EPA 542-R-13-006  
January 2013  
Office of Solid Waste and Emergency Response  
Office of Superfund Remediation and  
Technology Innovation

**Optimization Review**  
**Peck Iron and Metal Superfund Site**  
**Portsmouth, Virginia**

Report of the Optimization Review and  
Site Visit Conducted at the Peck Iron and Metal Superfund Site on  
February 22, 2012

January 18, 2013

**Figure 20. Optimization Team-Proposed Groundwater Investigation Decision Logic**

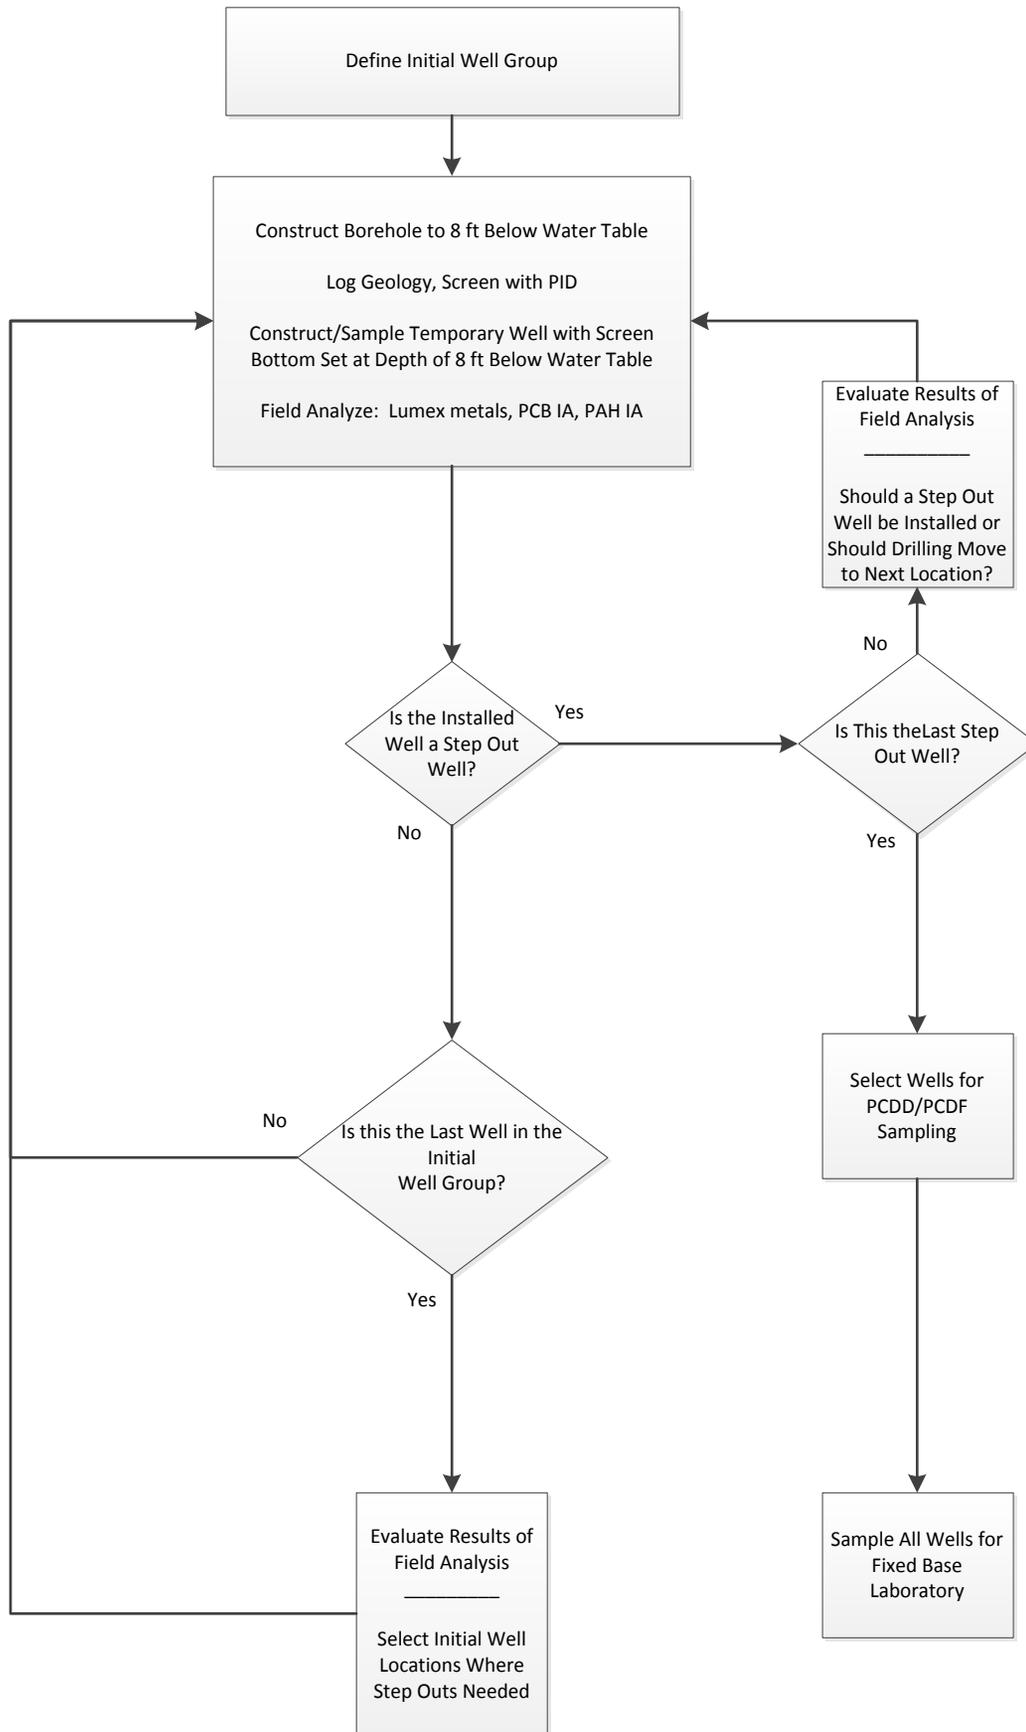
To increase the flexibility of the groundwater characterization, the following adaptive approach is recommended. The associated field logic is shown on Figure 20. Based on discussions with EPA (Rossi 2012), EPA Region 3 may reduce the final number of temporary wells from 24 to a total of 12. Given that 12 wells will be installed, the recommended approach consists of the installation of an initial subset of these wells (8 are proposed) with the remaining wells (four) installed based on the field data generated from the initial wells.
